Federal Emergency Management Agency

**IN REPLY REFER TO:
Case No.: 99-06-1226R**

Community: Bernalillo County, New Mexico
Community No.: 350001

CLOMR
for
Tract A, Unit 16
Sandia Heights South

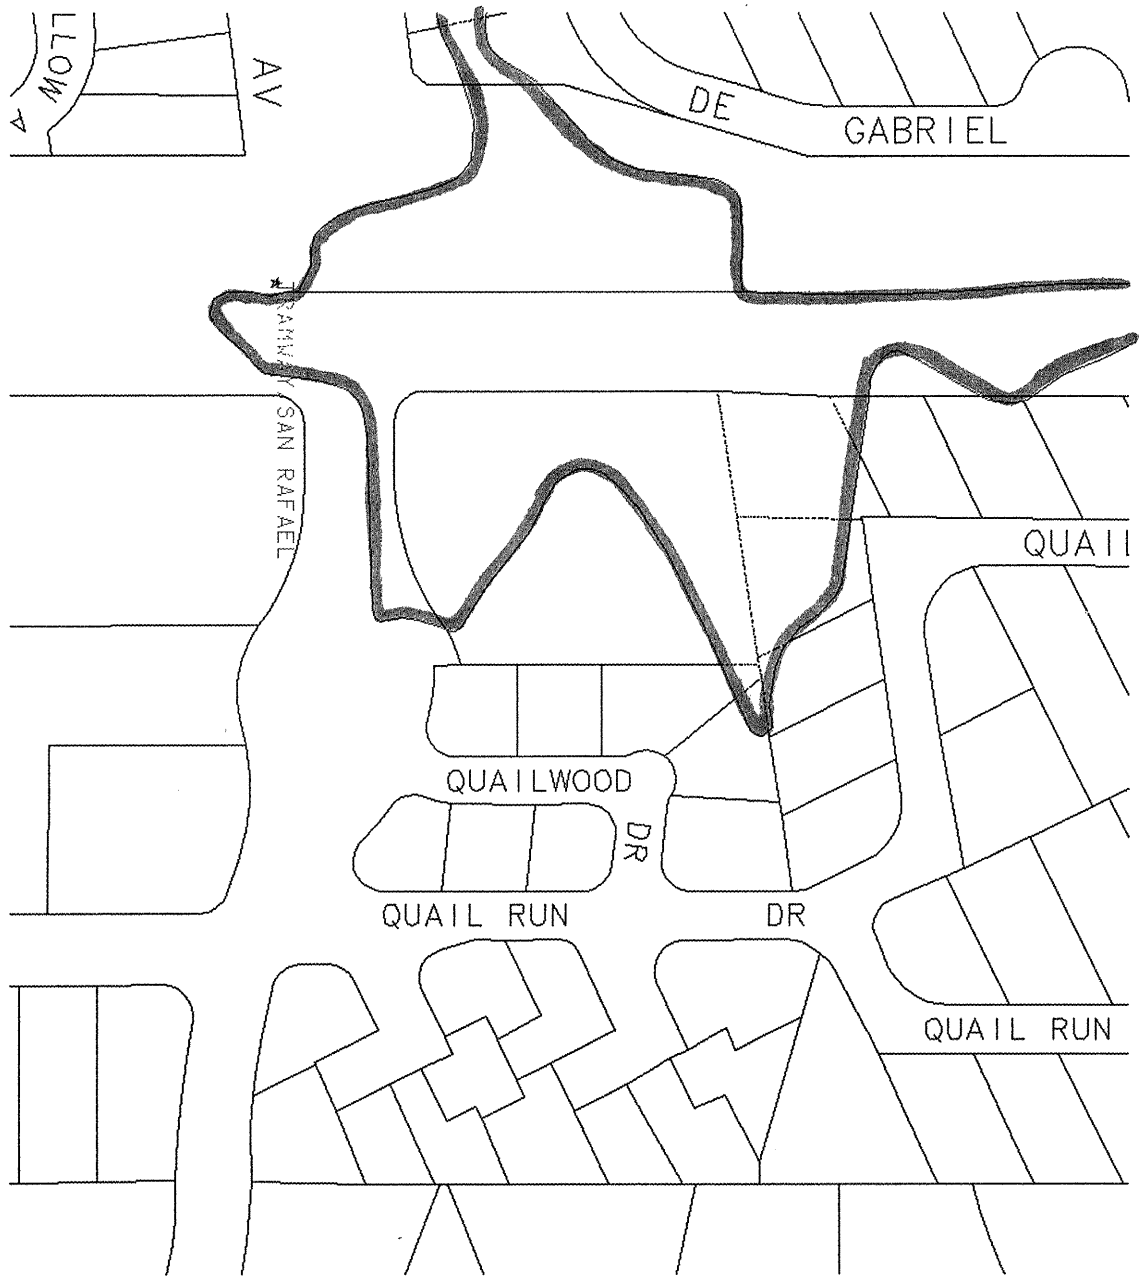
1. Because this site is to be subdivided, a Letter of Map Revision must be obtained from FEMA to remove the existing floodplain. The Plat must show the existing floodplain limits and must contain the standard floodplain note.

2. Is this Tract in Unit 16 or Unit 19 of Sandia Heights South? The City's AGIS identifies this as Unit 16. This must be correct on the Plat.
3. Is the existing 10' drainage easement public or private?

5. Please show the site correctly on the flood map. It appears that the FEMA floodplain encroaches more into the site. Revise the floodplain limits. (See map attached)

6. North arrows should be added to the Vicinity map and the FEMA map since these are not oriented the same way.
7. Per the legend, is the bold Boundary Line the property line, or a drainage basin boundary?

9. Provide the off-site drainage basin map. Is the pond intercepting public or private water? Is the proposed 8" pipe to be publicly or privately maintained?

12. Provide cross sections at the perimeter of the site, especially on the south and west sides to show the proposed slopes. Adjacent to Tramway, why are the flow arrows shown within the slope and how do the proposed spot elevations relate to the existing ground elevations?

13. Provide existing elevations on the east side of the site to show the grade differences between your site and the existing Lots.
14. Please provide a detail for the floodwall on the plan.
